Subject: Juniper Ridge Landfill Expansion Application, MEDEP #S-020700-WD-BI-N Follow-up to Department Staff's Responses to the March 4, 2016 Submittal on Staff's Review Comments as Presented in the Department's April 5, 2016 Letter

BGS AND NEWSME'S RESPONSE TO MEDEP'S APRIL 1, 2016 TECHNICAL MEMORANDA

I. April 1, 2016 Technical Memorandum Authored by Mr. Richard Behr

\\server1\CFS\Casella\OldTown\Landfill\Expansion\9.35\MCY-Expansion\Project Regulatory Review\Acad\Figures\PumpTests-BR-TILL.dwg, 5/11/2016 12:56:50 PM, paf

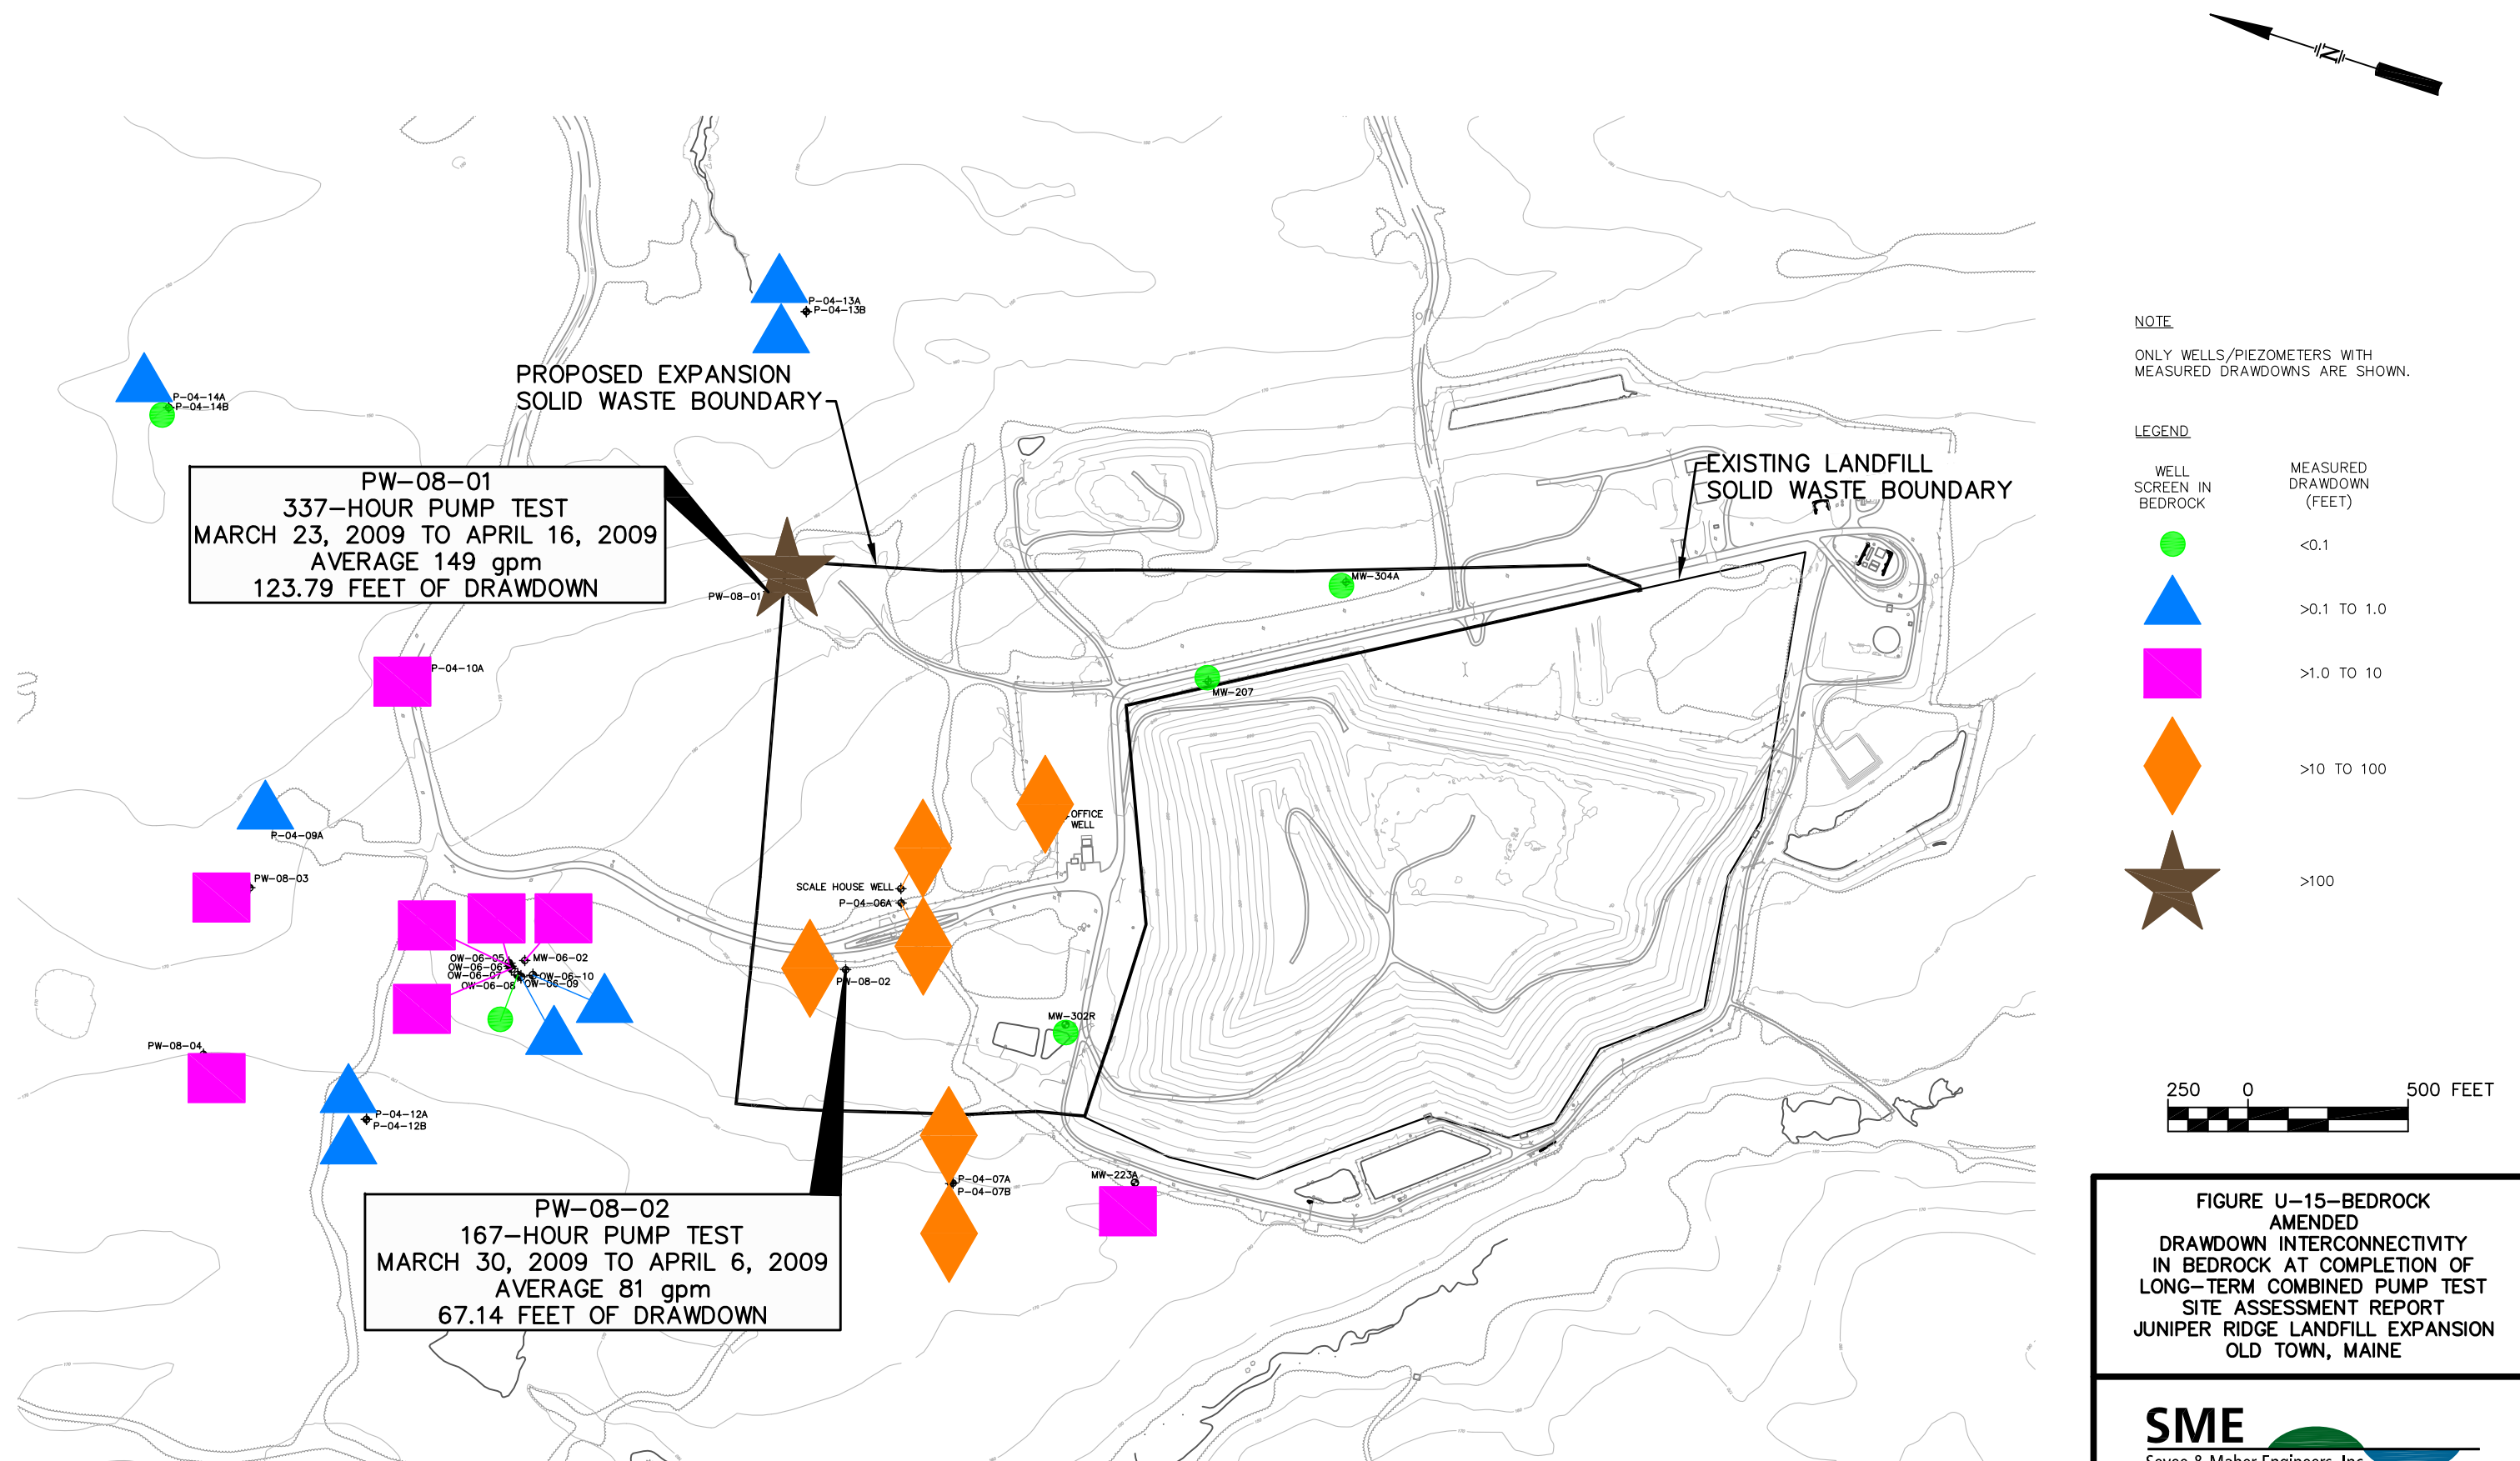
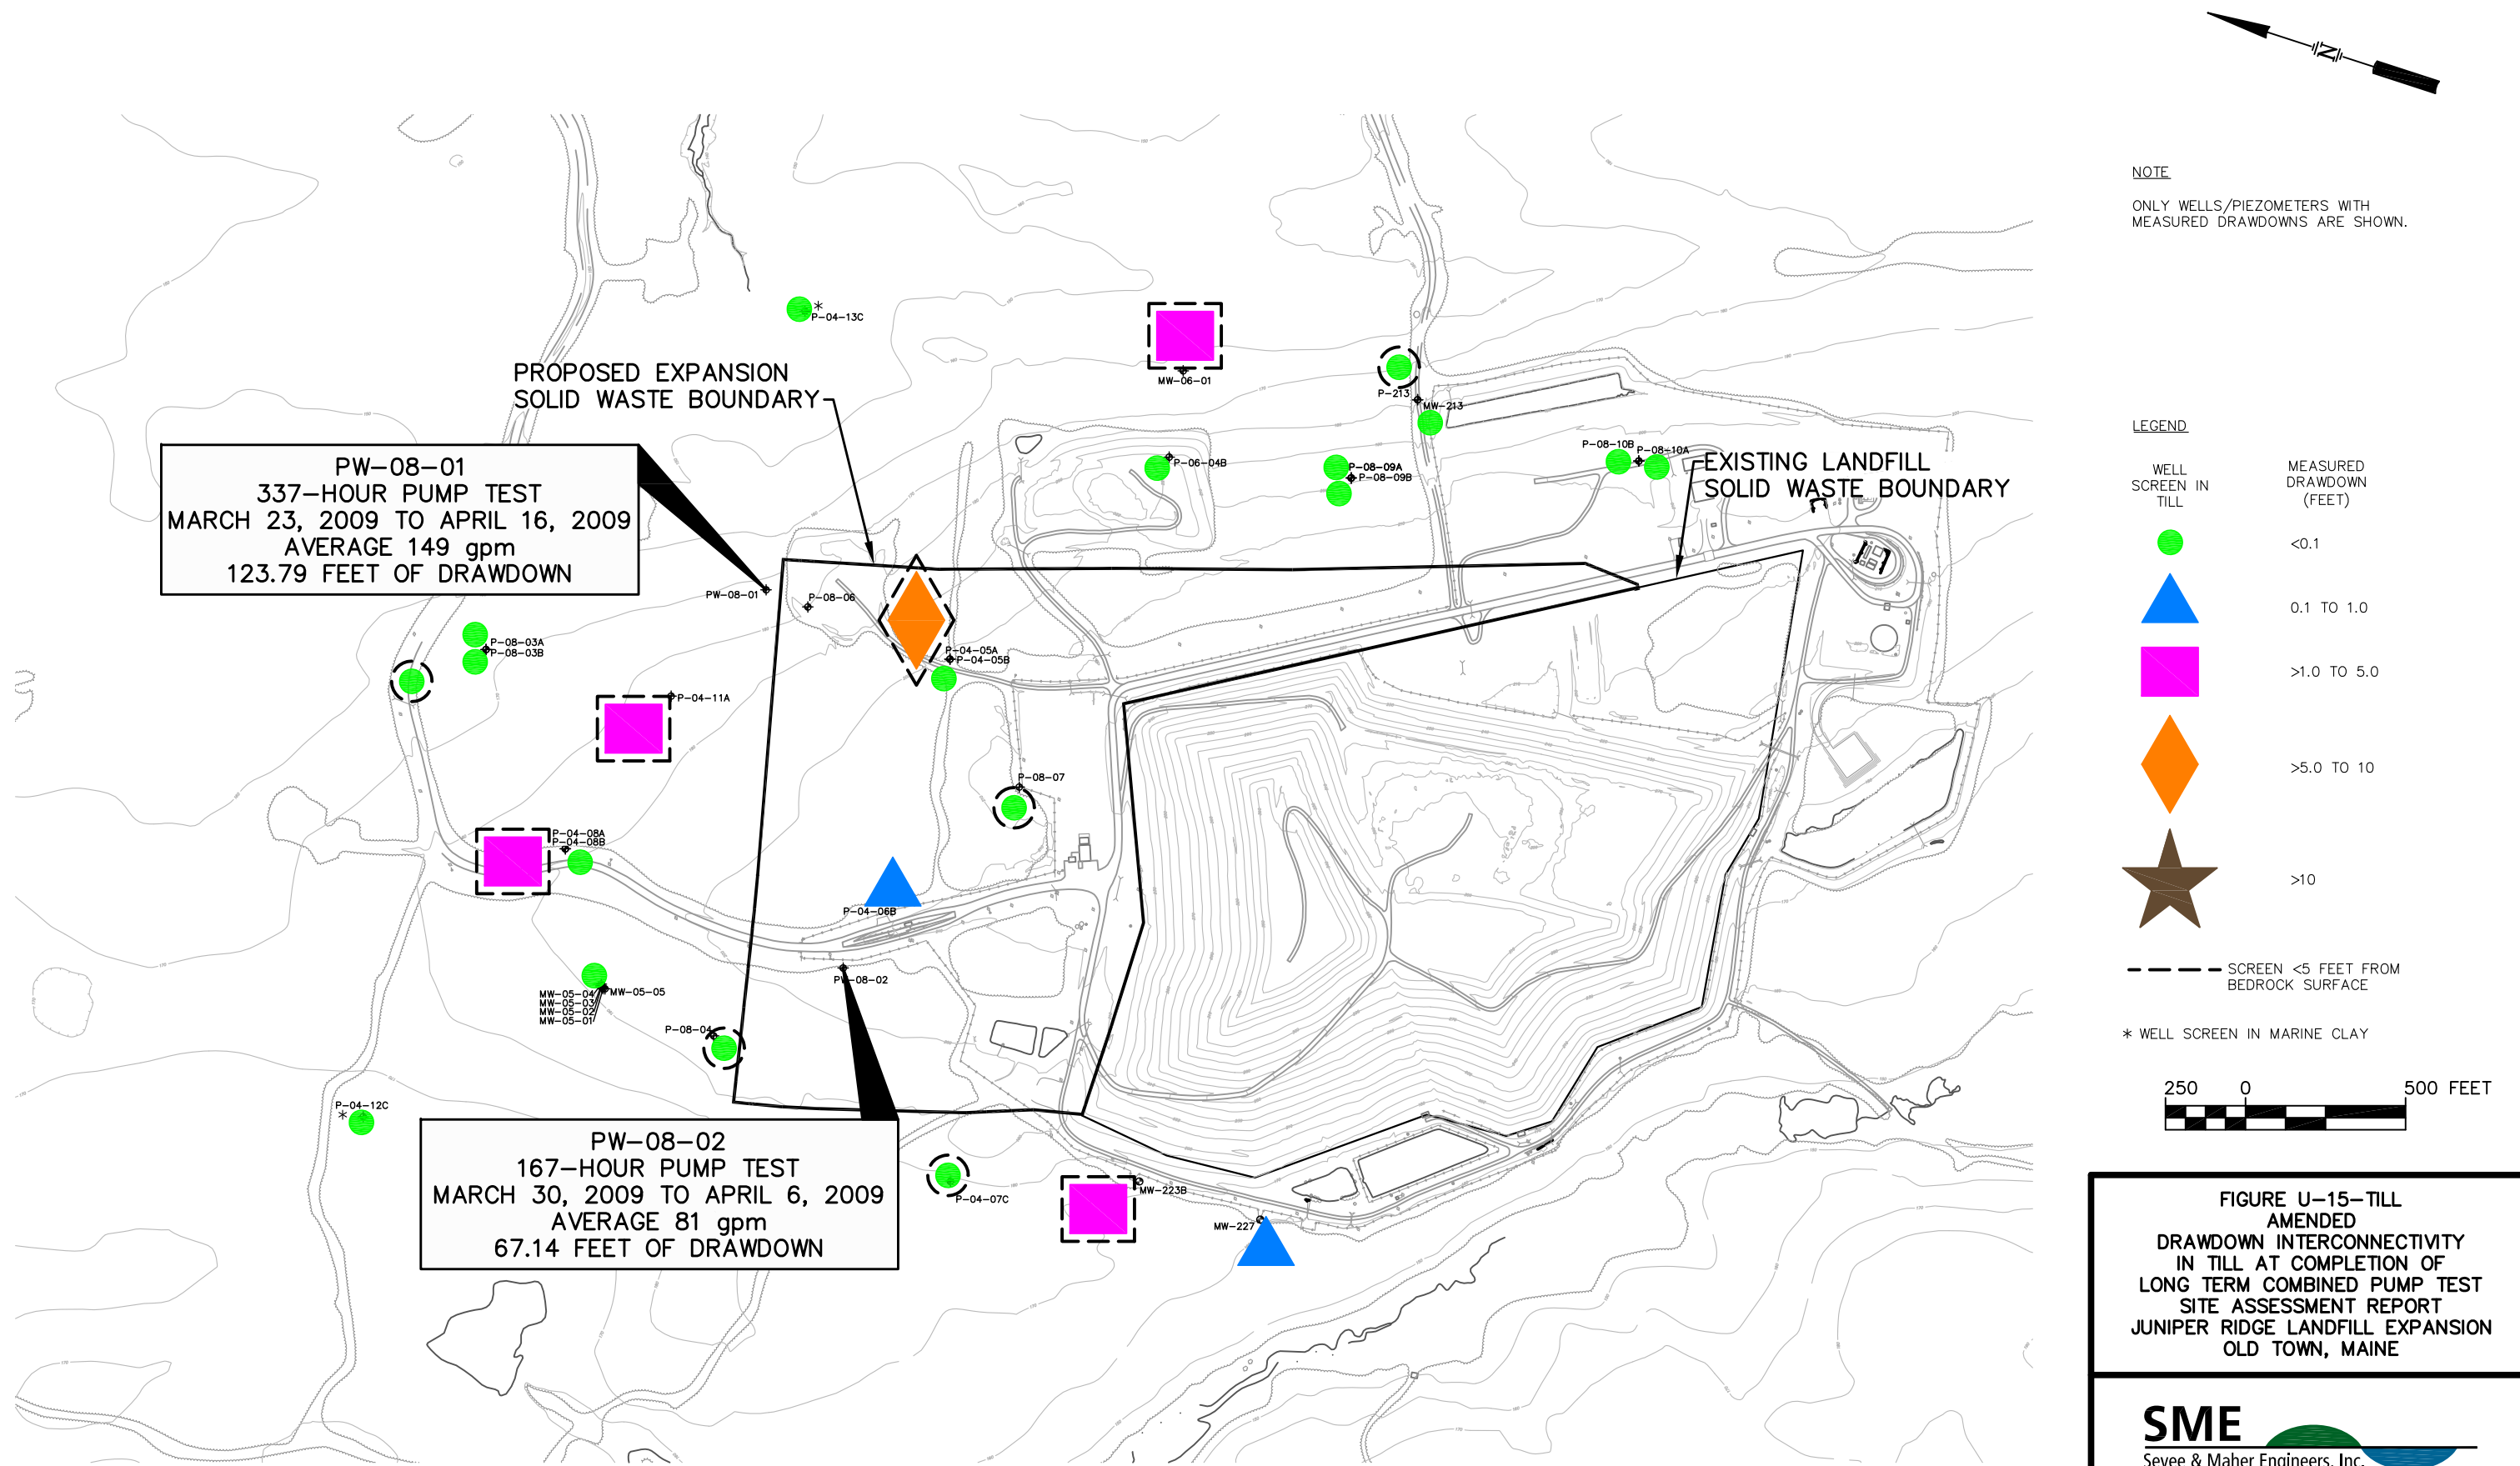
MEDEP Follow-on Response: My original comment included a request for figures to illustrate the observed drawdowns in monitoring wells screened in the till. JRL's

response did not include the requested figures. I continue to assert that a graphic depiction of locations where the till is hydraulically connected to the underlying bedrock is important and may assist in locating wells for long term monitoring and extraction wells in the unlikely event a significant leachate release were to occur.

MEDEP – Follow-on Response: The referenced figures were included in the original application but they do not differentiate the till wells from the bedrock wells. I continue to believe JRL should produce figures that depict the till wells where drawdowns were observed during the long-term pumping tests. These figures may help in the evaluation of long term monitoring well locations.

MEDEP – Follow-on Response: JRL's response to my comments about Figures U-14 and U-15 do not adequately address my comments. Additional figures are needed to properly illustrate the data collected during each of the five pumping tests. To further enhance the results of the pumping test data, it is necessary to include all of the drawdown data obtained during each test. Again, I contend it is important to differentiate between bedrock and till wells. As an example, the figure (Figure U-14) illustrating the 26.5 hour pumping test performed on PW-08-04, uses graduated symbols to depict the range of observed drawdowns for only 20 of the 53 wells where water levels were observed. There are also apparent inaccuracies on the existing figures. The text on page 26 states six wells (5 bedrock and 1 till) experienced between 0.1 and 1.0 foot of drawdown although Figure U-14 only depicts three wells in this range. The figure (Figure U-15) depicting the drawdowns observed during the long-term pumping tests at PW-08-01 and PW-08-02 also requires revisions as only a fraction of the drawdown data is depicted on this figure. Although JRL collected drawdown data for 53 wells during the tests, Figure U-15 only depicts data for 21 wells.

To address these comments, I recommend JRL display all of the drawdown data for each pumping test on appropriately scaled figures. I also ask JRL to augment the drawdown data included in Appendix M with a table summarizing the total drawdown observed in all wells during each of the pumping tests. This table would include those wells instrumented with pressure traducers and those where manual water levels were made. I am certain JRL has previously compiled this data to complete the pumping tests analyses. I also request that JRL also provide the Department with an electronic copy of the spreadsheet.

Applicants' Response: Included in Attachment SME-D3 are ten figures augmenting Figures U-14 and U-15 included in Appendix U of Volume II of the Application. These figures show monitoring wells and piezometers where drawdowns were measured during the pumping tests. For each pumping test two figures, one showing the drawdown in the bedrock, and one showing the drawdown in the till, have been prepared. On the figures showing the drawdowns in the till the locations where the instrument screen is located within five feet of the bedrock surface are identified.

Applicants' Response: See previous response to the comment regarding Appendix U, Pg 25, 5.0 Pump Test Proof of Bedrock Interconnectivity. These figures are contained in Attachment SME-D3.

Applicants' Response: See previous response to the comment regarding Appendix U, Pg 25, 5.0 Pump Test Proof of Bedrock Interconnectivity. The augmented U-14 and U-15 figures are contained in Attachment SME-D3.

WATER LEVELS NEAR MW-06-02 AROUND TEST PERIOD

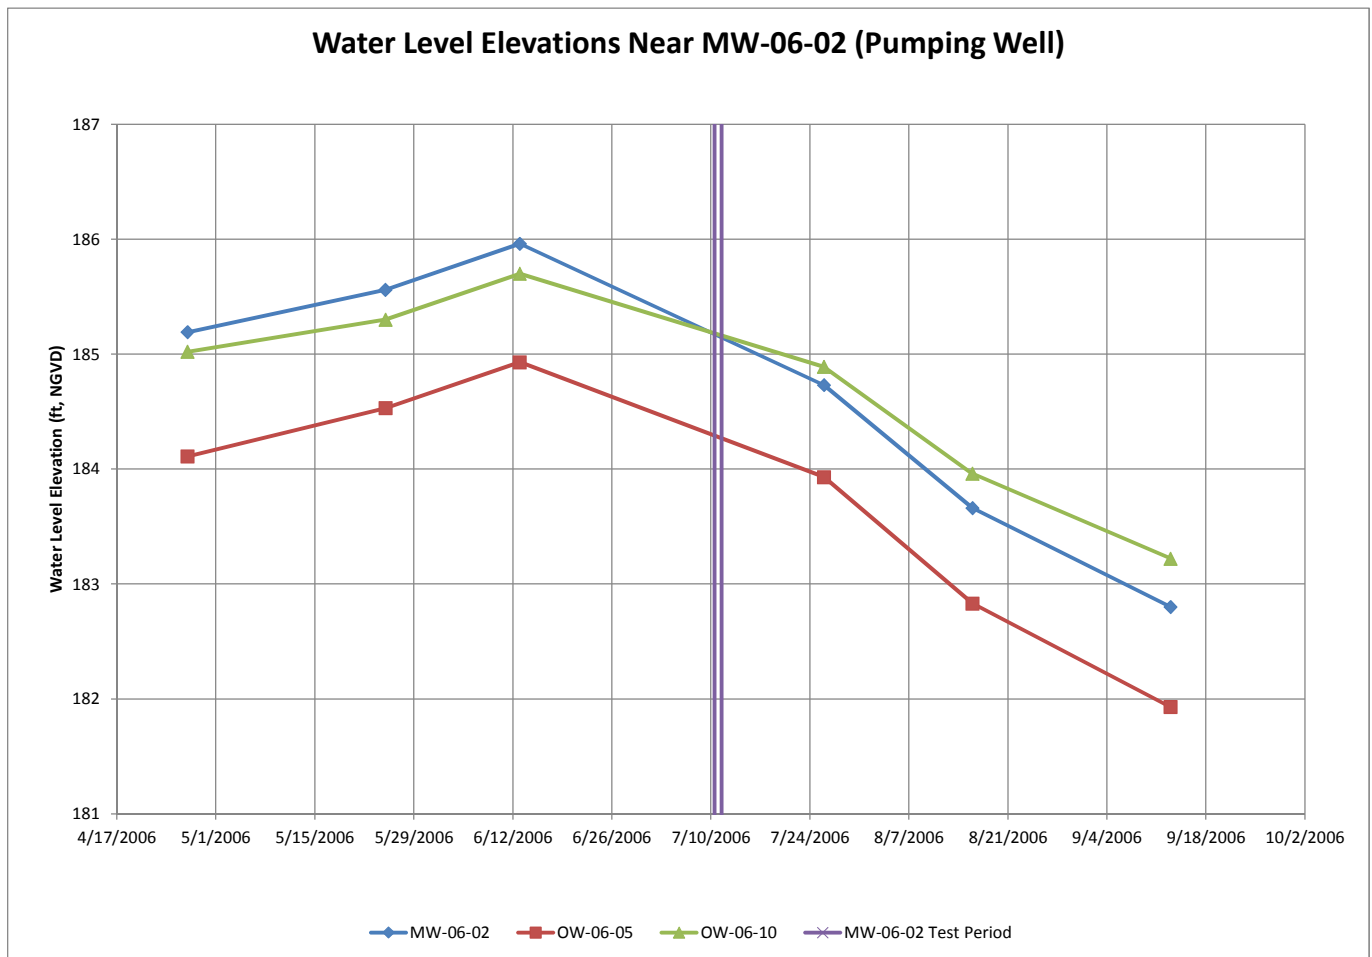
MEDEP Follow-on comment: We respectively disagree; prior water elevation data is always necessary. If water levels are decreasing at one well and not the others, it would appear that there was a response at that well even if it wasn't responding to the pumping well. For example, in the third paragraph in Section 4.0, there is uncertainty about the drawdown at OW-06-06; "The maximum drawdown reading during the pump test was approximately 0.16 feet. This may merely be natural fluctuation in the groundwater elevation as there is no apparent recovery from the pump test." If you had monitored water elevations prior to the pumping test, this may have helped assess the response at this well.

Applicants' Response: We have been unsuccessful in finding water level measurements a day or two before the pump test. We did, however, find in our electronic data base, water levels measured at three wells (MW-06-02, OW-06-05 and OW-06-10) over the spring and summer at approximately one month intervals. A graph of these water level measurements is in SME-D7 and shows an average water level decline of about 0.03 foot per day during the July period. This decline rate amounts to a correction of less than a 0.005 foot during the first 200 minutes of the test (i.e., before the rain event) and about 0.01 foot for the entire eight hour pump test. Data from the first 200 minutes was the only part of the drawdown record used to calculate bedrock transmissivity and storativity. This magnitude of correction is inconsequential to our transmissivity results and, most importantly, does not alter our conclusions about the interconnectivity of the bedrock fractures at this site.
